ADDENDUM NO. 01

PROJECT: Pleasantville Union Free School District

PMS HVAC Replacement

DATE: October 31, 2022

AD-1 SK-1

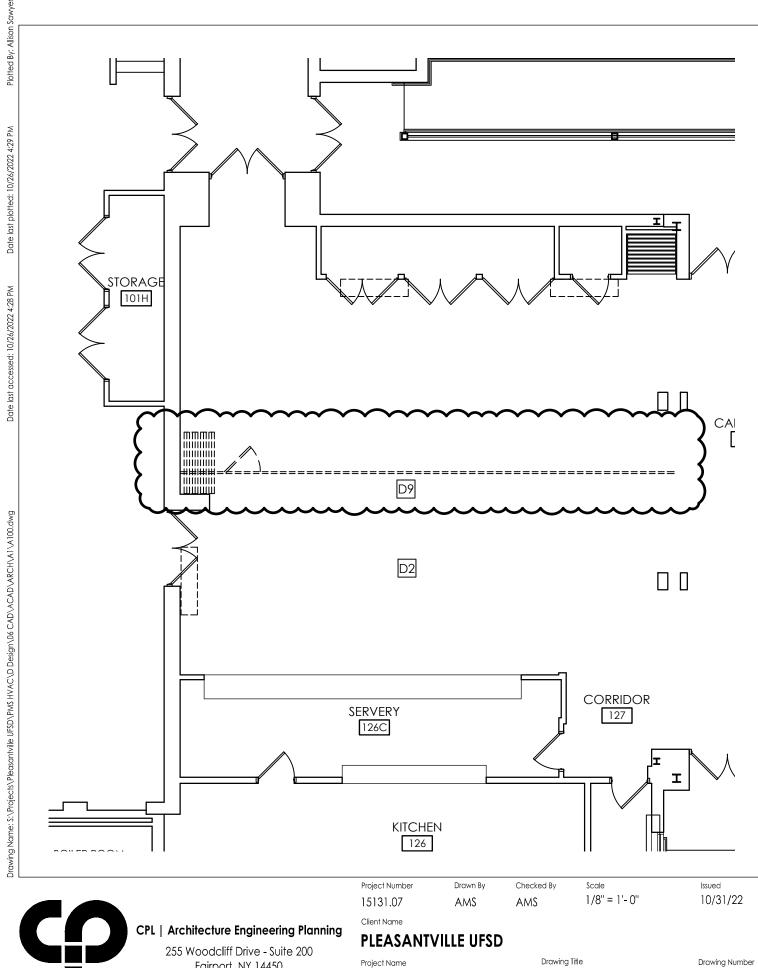
- 3.2 <u>Drawing A100A</u>: **Replace** sheet with attached sheet A100A.
- 3.3 <u>Drawing A100B</u>: **Revise** drawings with attached sketch AD-1 SK-1 and attached sketch AD-1 SK-2.
